**REDTAIL RANCH**

**PRELIMINARY PLAN AND FINAL PLAT**

**LETTER OF INTENT**

**JULY 2018**

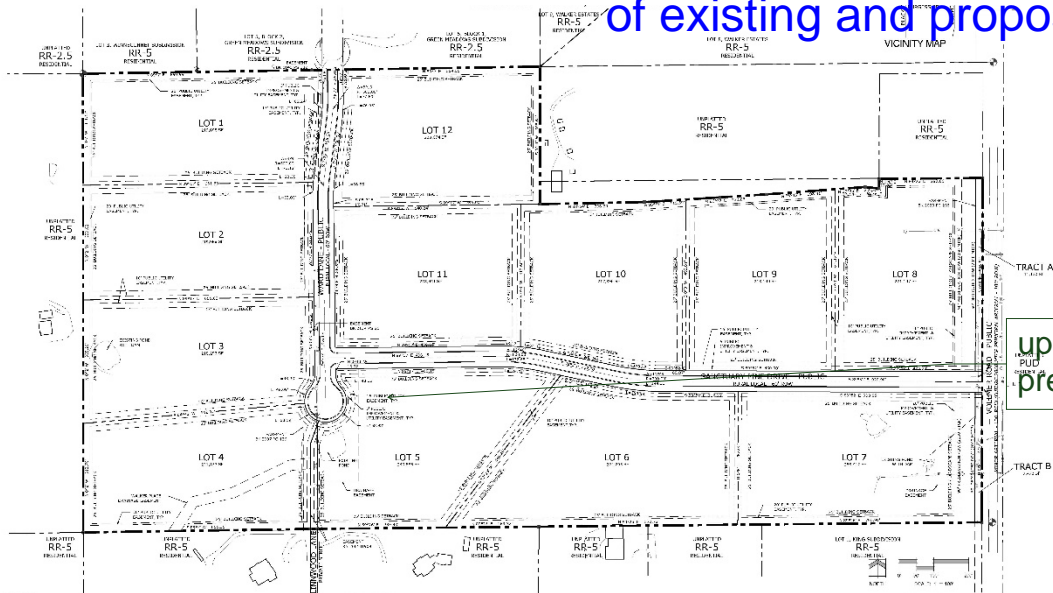
Sanctuary Pine Drive to be aligned across Vollmer Rd.
